Proposed Modifications to 1000BASE-T1 State Diagrams and Variables

May 18, 2015

Peiqing Wang and Mike Tu

Figure 97–23—Link Monitor state diagram

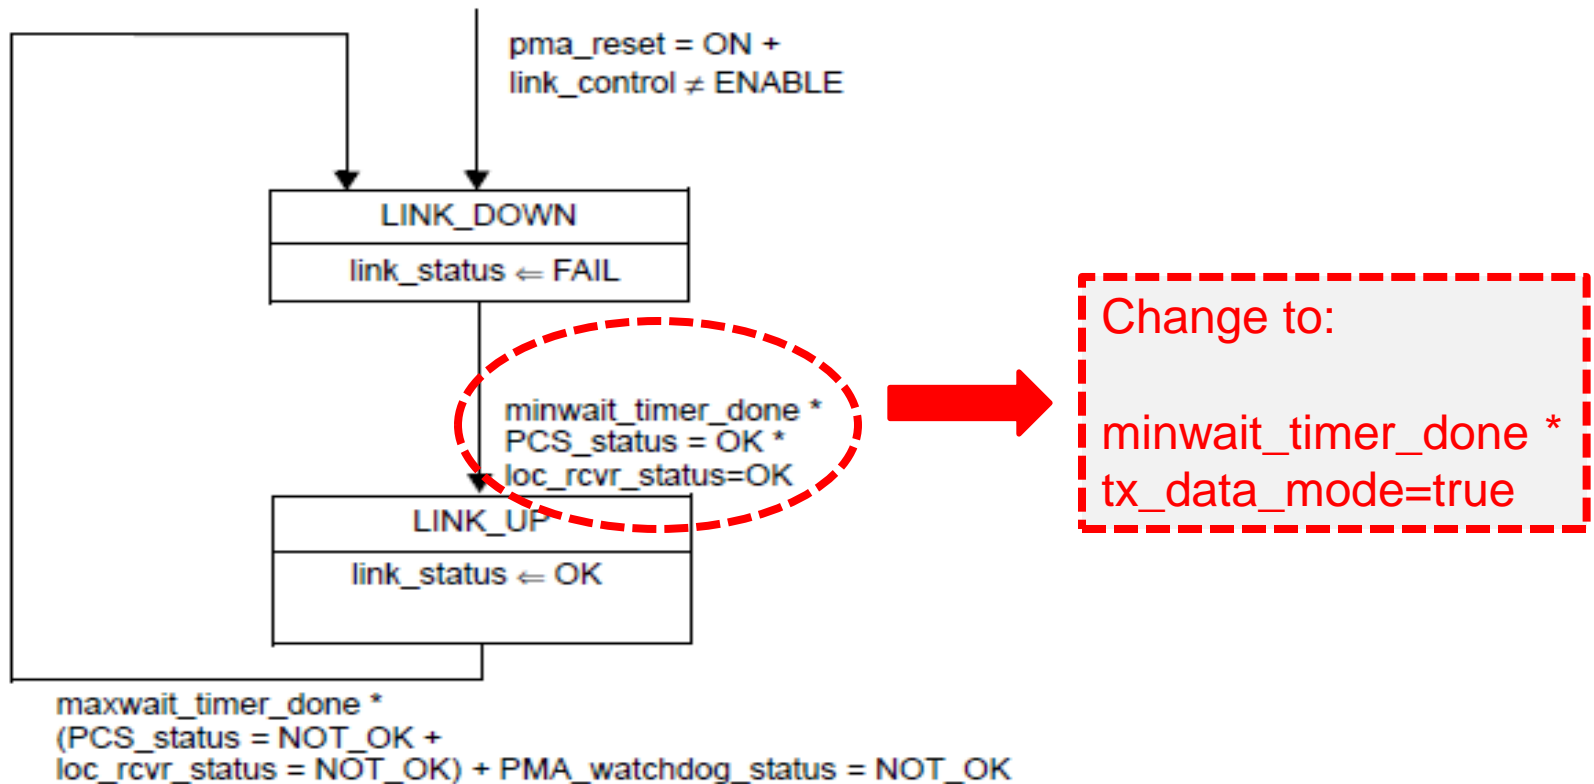
- The condition from “LINK_DOWN” state to “LINK_UP” state is shown as:
 - `minwait_timer_done * PCS_status=OK *
loc_rcvr_status=OK.`
- However, this condition will become true during the PAM2 training, before entering the data mode, resulting in “LINK_UP” declared too early.

Remedy for Figure 97-23

- On page 80, line 26:
- tx_data_mode
 - Set true when tx_mode = SEND_N, otherwise false.
- This variable is only set to TRUE after tx_mode=SEND_N → no ambiguity.

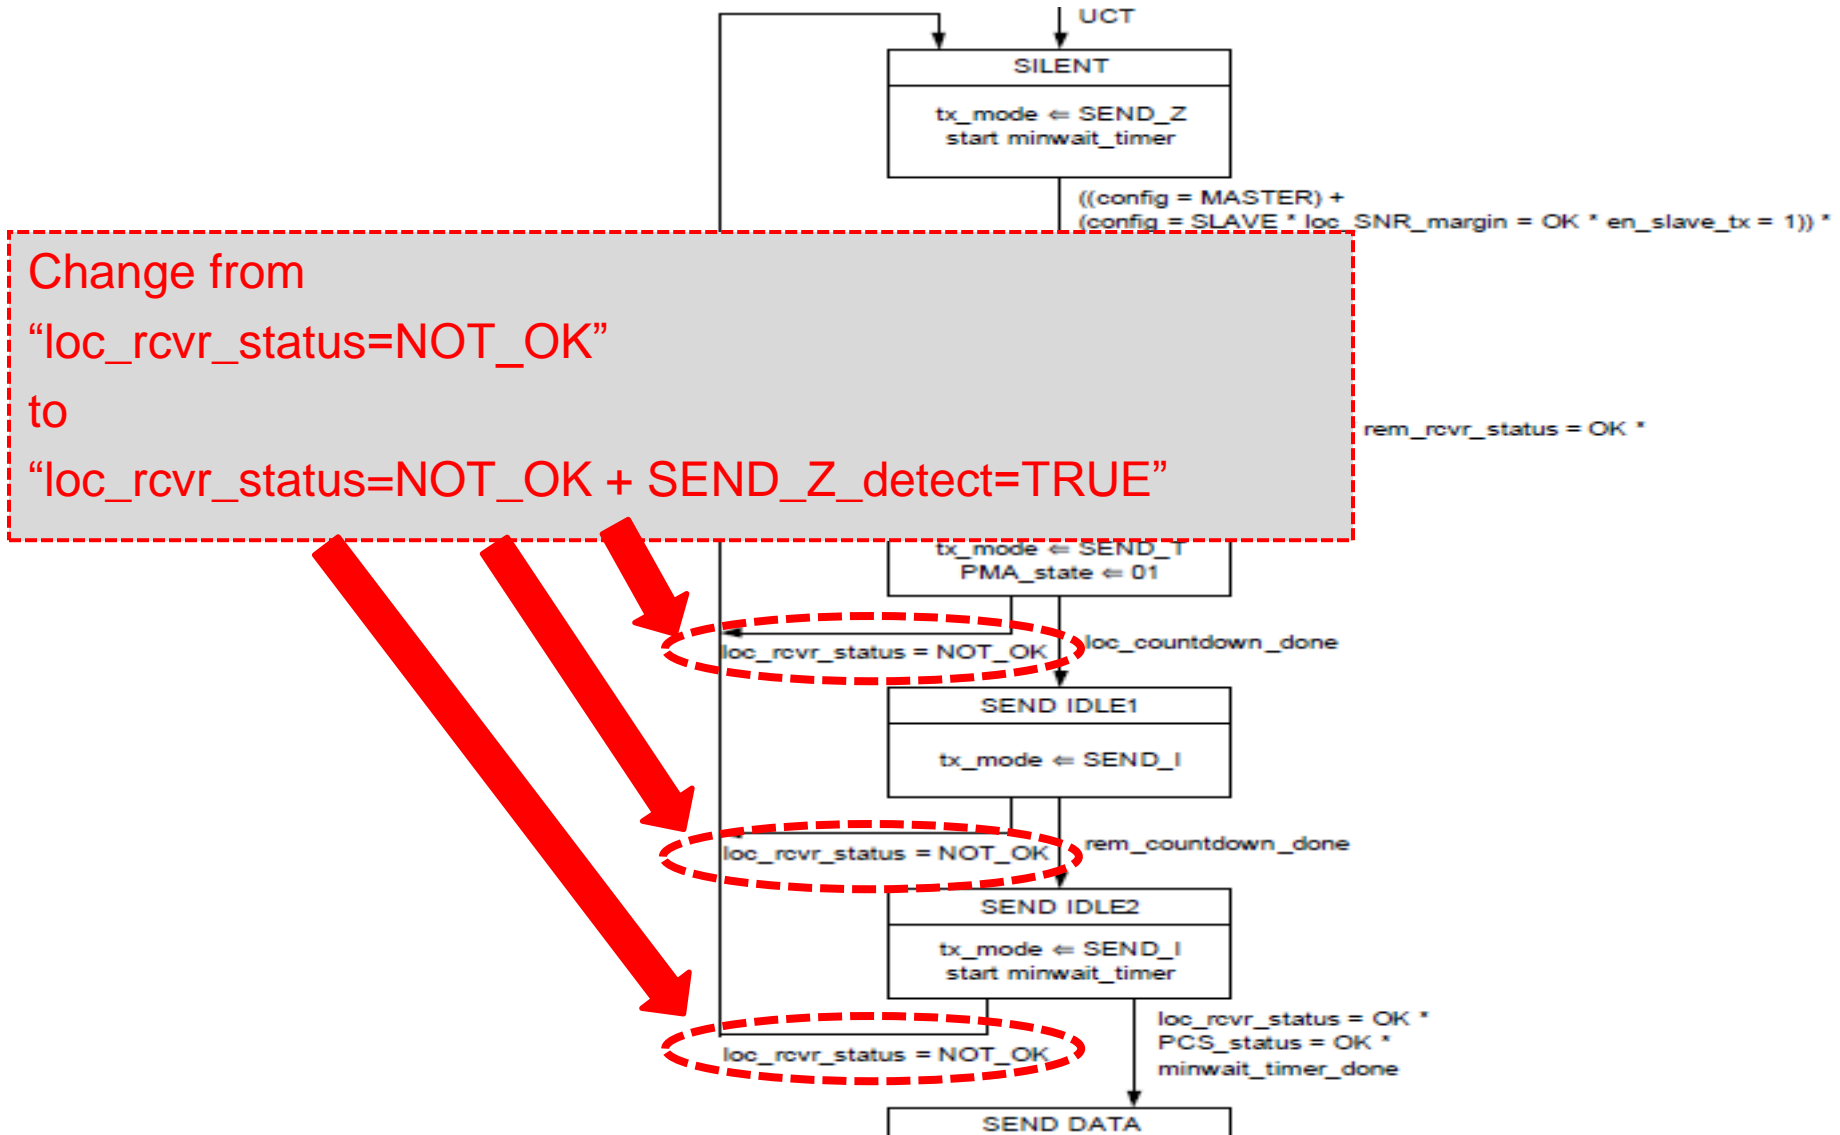
What happens when link partner drops back to SILENT state during training??

- Link partner drops back to SILENT state
 - Link partner tx_mode <= SEND_Z
 - Last for at least minwait_timer ≈ 1msec
- The local receiver will receive all 0.
- We want the local PHY to jump to SILENT state quickly in order to attempt retrain.
- Based on D1.4, the local receiver must set loc_rcvr_status=NOT_OK under this condition.
- However ...

- New state variable for 97.4.4.1
- SEND_Z_detect
 - This variable is used during the COUNTDOWN, SEND_IDLE1, and SEND_IDLE2 states. It detects when the remote link partner is transmitting SEND_Z.
- Values:
 - TRUE: Remote link partner is transmitting SEND_Z.
 - FALSE: Remote link partner is not transmitting SEND_Z.

Figure 97–23—Link Monitor state diagram

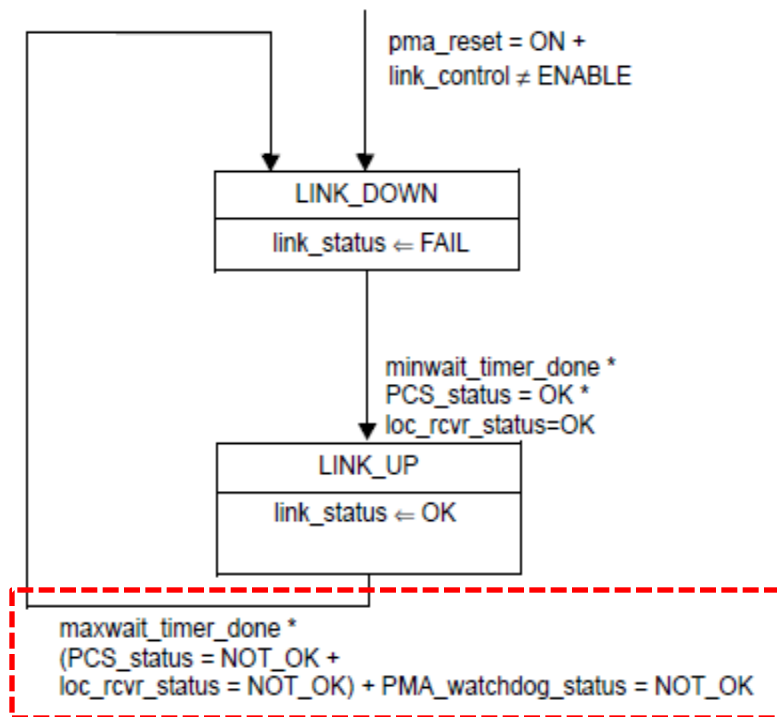
- Figure supersedes text descriptions.

- A 1000BASE-T1 PHY supporting the EEE capability shall implement the Refresh monitor function. The Refresh monitor operates when the PHY is in the LPI receive mode. **The receiver shall force a retrain if Refresh is unreliably detected within a moving window of 50 Q/R cycles (4.32 ms).**

Add this condition into Figure 97-23.

- Change 97.4.2.7. Page 94, line 4-5, from
 - "The receiver shall force a retrain if Refresh is unreliably detected within a moving window of 50 Q/R cycles (4.32 ms)."
- To
 - "If Refresh is not reliably detected within a moving window of 50 Q/R cycles (4.32 ms), the refresh monitor shall set PMA_refresh_status to FAIL. This will set link_status to FAIL. Subsequently the PHY will restart auto-negotiation (if auto-negotiation is enabled) or synchronization (if auto-negotiation is disabled)."

- PMA_refresh_status
 - Variable indicating the status of the Refresh Monitor.
- Values:
 - OK: Refresh is detected reliably.
 - FAIL: Refresh is not detected reliably.

Figure 97–22—PHY Control state diagram

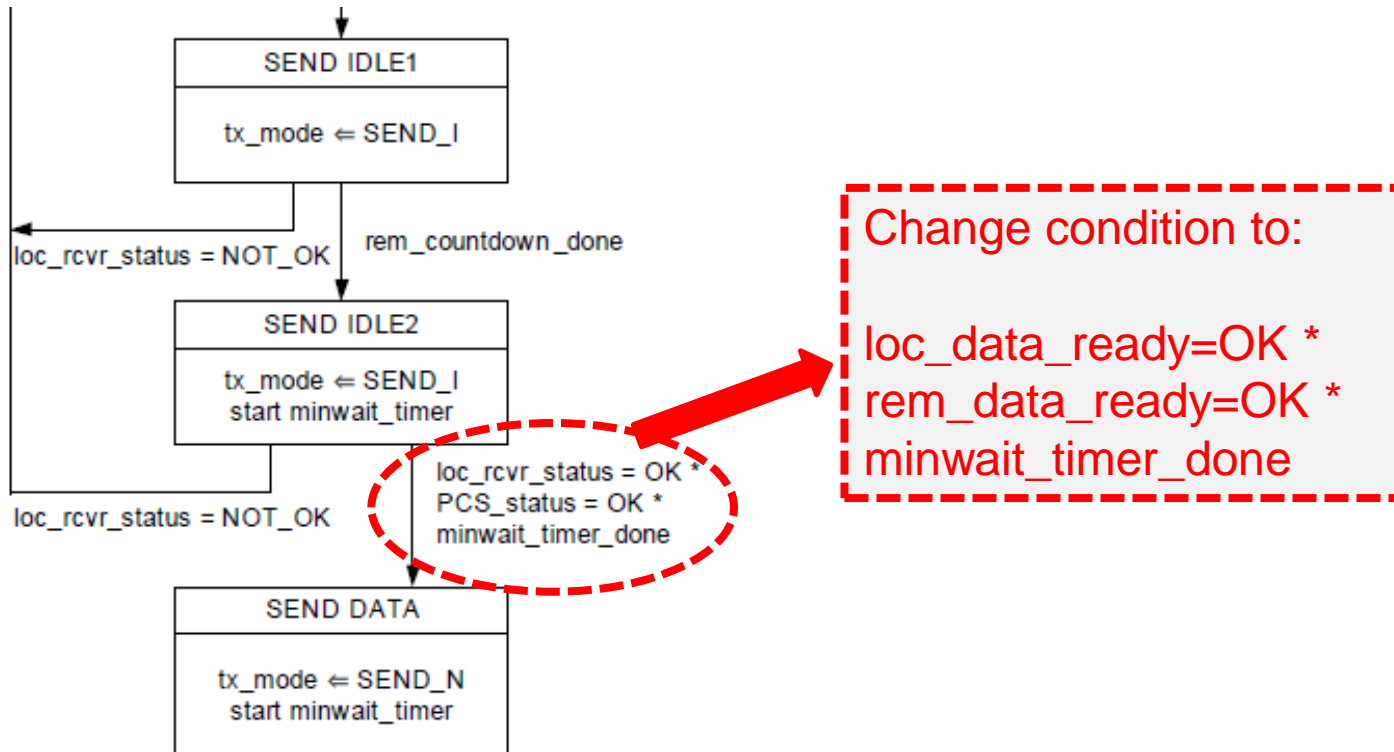
- In Figure 97-22, when entering SEND_DATA state, the decision is purely based on local receiver and PCS status.
- Once in SEND_DATA mode the local PHY will set link_status<=OK and MAC will start sending data out.
- However at this time the link partner receiver may not be ready yet, for example due to noise events. Under this condition the data packets sent to the link partner will be lost.

Proposed Changes

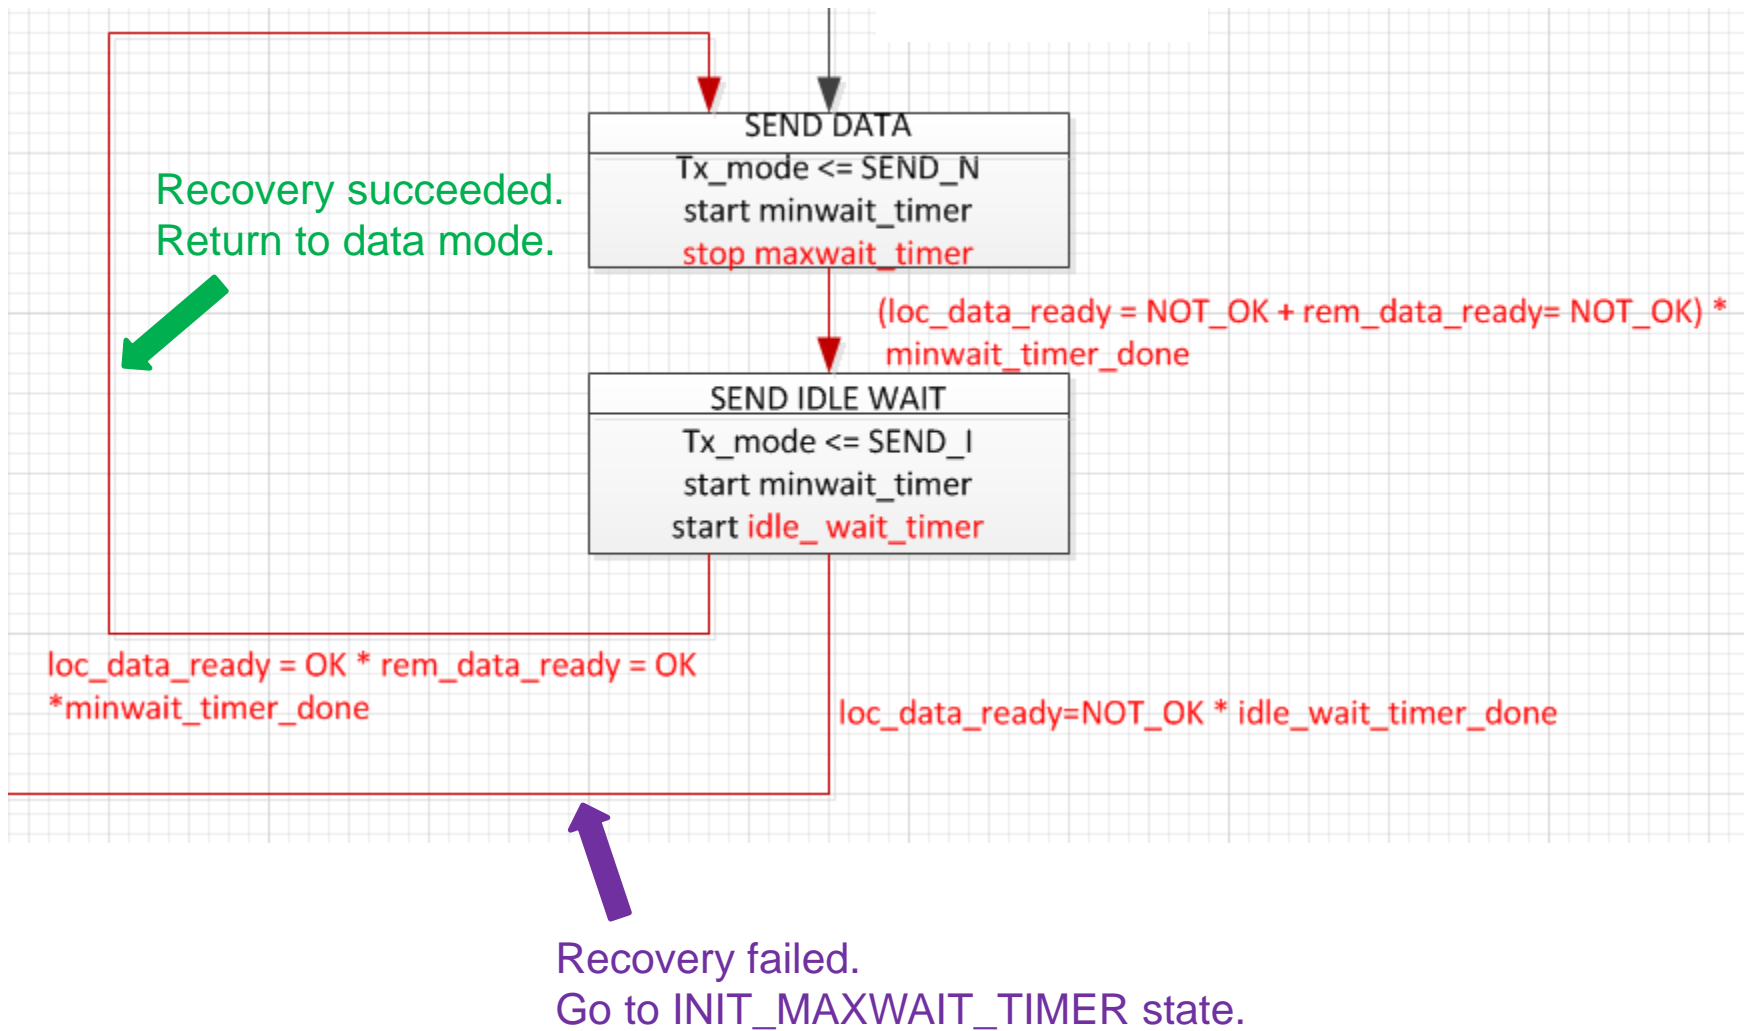
Comment #569 from Brett

Proposed Figure 97-23 and Figure 97-22 with all changes

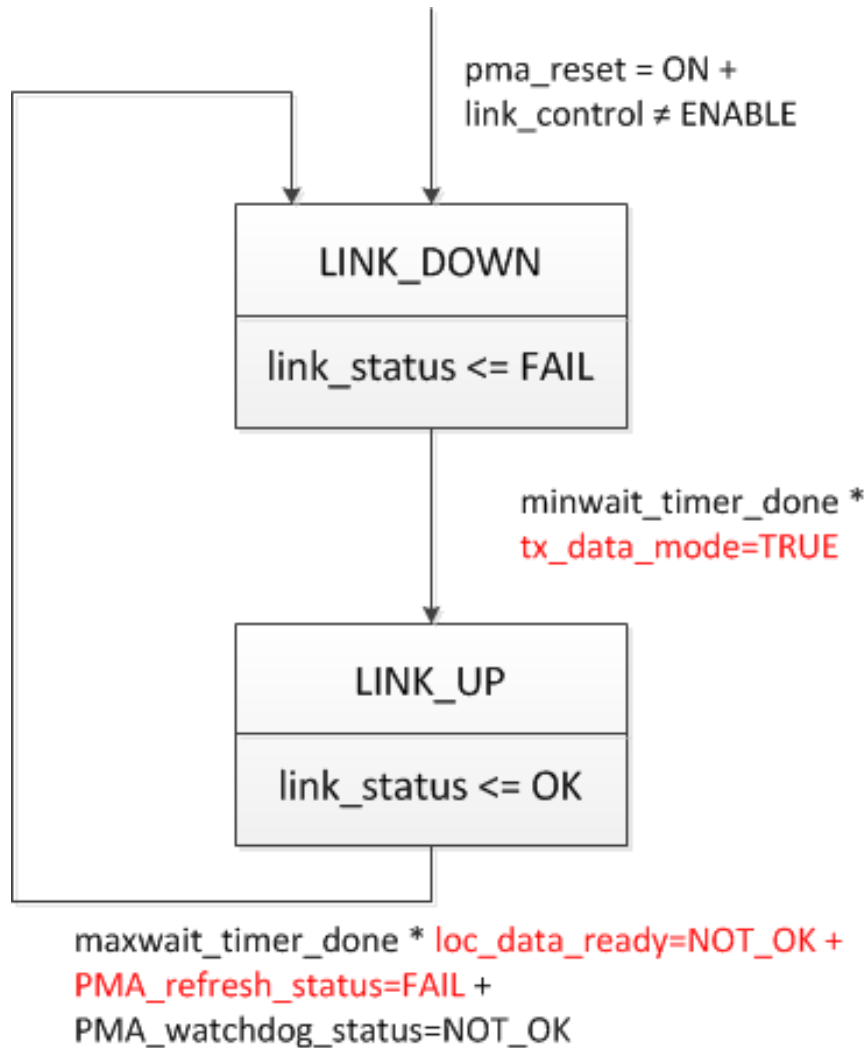
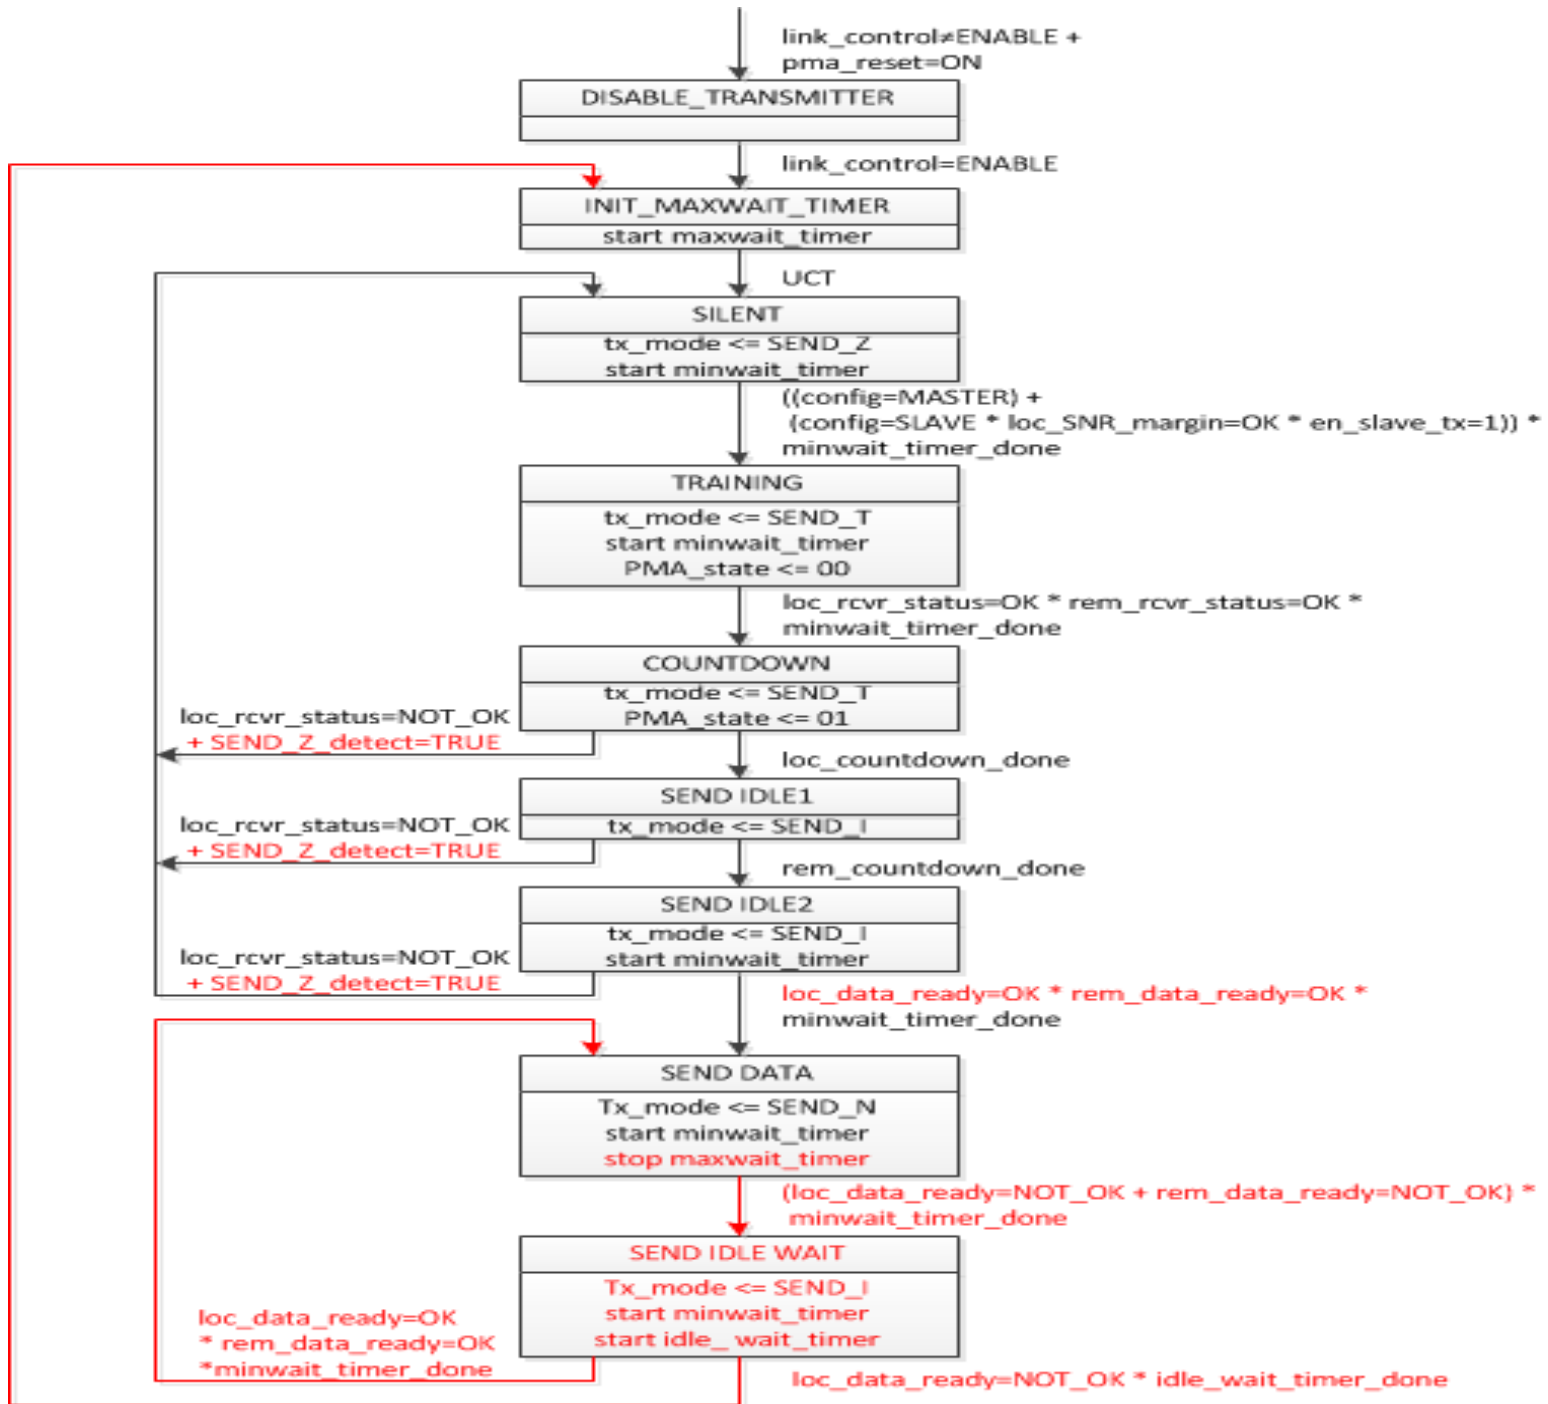
- Before jumping back to half-duplex training mode, stay in 3B2T for “some time”, then check status again.
 - If PHY receiver recovers, then stay in data mode
 - If PHY receiver still can not recover, then do a full retrain
 - During this time, indicate loc_data_ready=NOT_OK to link partner
- Define “idle_wait_timer”
 - About 10msec should be sufficient
- Some changes to Figure 97-22

Changes to Figure 97-22
